Office Action Summary

09/929,488

MATSUMOTO, KIMIKAZU

DETAILED ACTION

FIG. 1A(PRIOR ART)

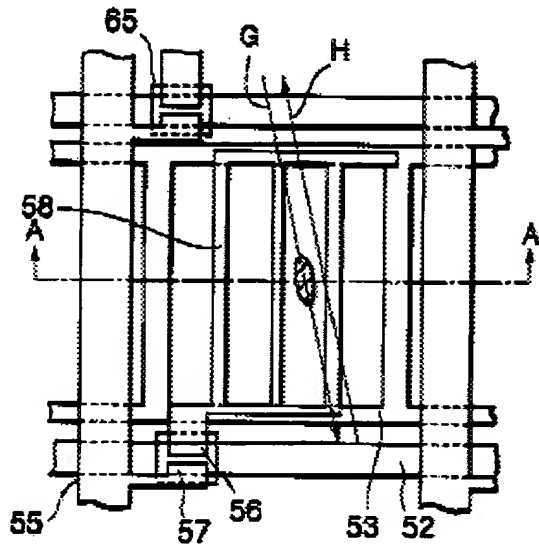
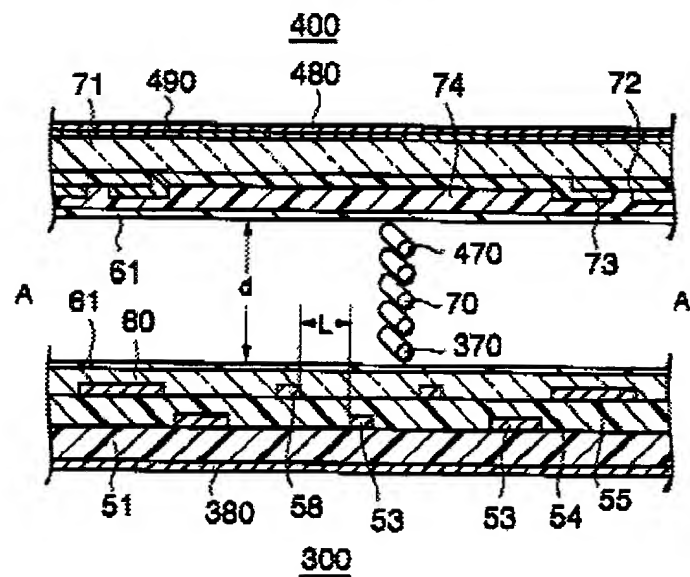
As to claims 8 and 9, Baur does not explicitly disclose a display wherein a gate wiring of a thin film transistor is formed on said first substrate simultaneously with said common wiring and wherein an island disposed above said common wiring and made of a semiconductor film is formed in said insulating film, and said island constitutes an active region of a thin film transistor. However, these are merely common knowledge means of comprising a satisfactory TFT display configuration.

Applicant's admitted prior art (APA) discloses these claimed features in Applicant's Figures 1A and 1B to comprise a satisfactory TFT display configuration.

APA is evidence that ordinary workers in the art of liquid crystals would find the reason, suggestion, or motivation to add a display wherein a gate wiring of a thin film transistor is formed on said first substrate simultaneously with said common wiring and wherein an island disposed above said common wiring and made of a semiconductor

film is formed in said insulating film, and said island constitutes an active region of a thin film transistor to comprise a satisfactory TFT display configuration.

Therefore, it would have been obvious to one having ordinary skill in the art of liquid crystals at the time the invention was made to modify the LCD of Baur with a display wherein a gate wiring of a thin film transistor is formed on said first substrate simultaneously with said common wiring and wherein an island disposed above said common wiring and made of a semiconductor film is formed in said insulating film, and said island constitutes an active region of a thin film transistor of APA to comprise a satisfactory TFT display configuration.

FIG.2

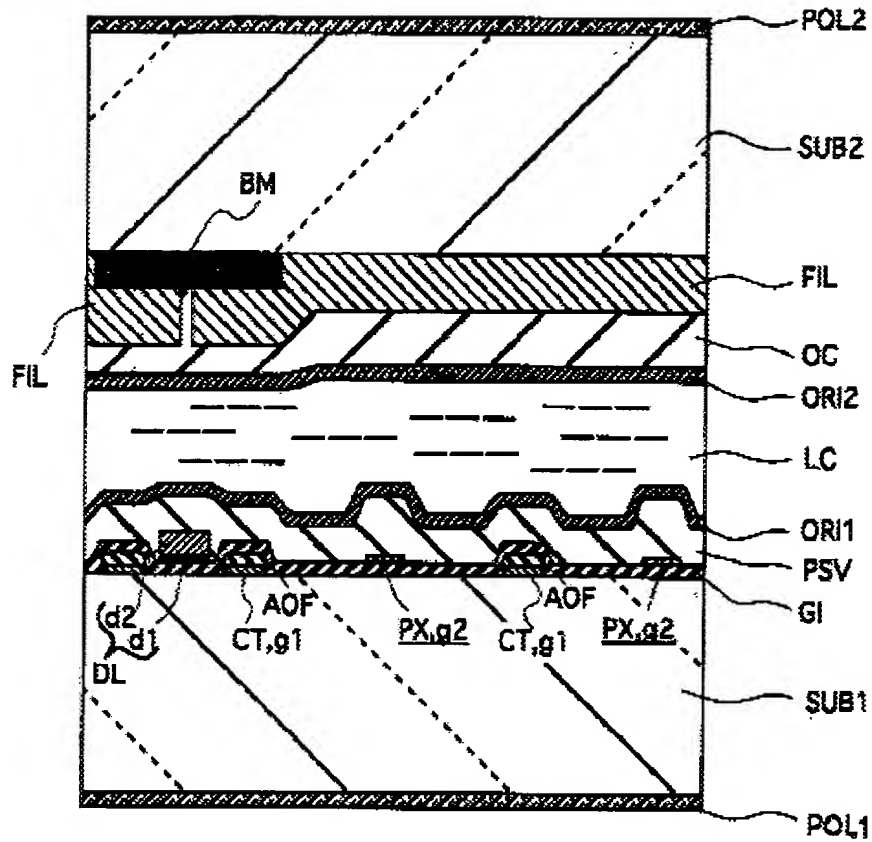
As to claims 8 and 9, Baur does not explicitly disclose a display wherein a gate wiring of a thin film transistor is formed on said first substrate simultaneously with said common wiring and wherein an island disposed above said common wiring and made of a semiconductor film is formed in said insulating film, and said island constitutes an active region of a thin film transistor. However, these are merely common knowledge means of comprising a satisfactory TFT display configuration.

Ohta discloses these claimed features in Figures 2 and 3 to comprise a satisfactory TFT display configuration with *inter alia* wide viewing angle (Abstract).

Therefore, it would have been obvious to one having ordinary skill in the art of liquid crystals at the time the invention was made to modify the LCD of Baur with a display wherein a gate wiring of a thin film transistor is formed on said first substrate simultaneously with said common wiring and wherein an island disposed above said common wiring and made of a semiconductor film is formed in said insulating film, and

said island constitutes an active region of a thin film transistor of Ohta to comprise a satisfactory TFT display configuration with wide viewing angle.
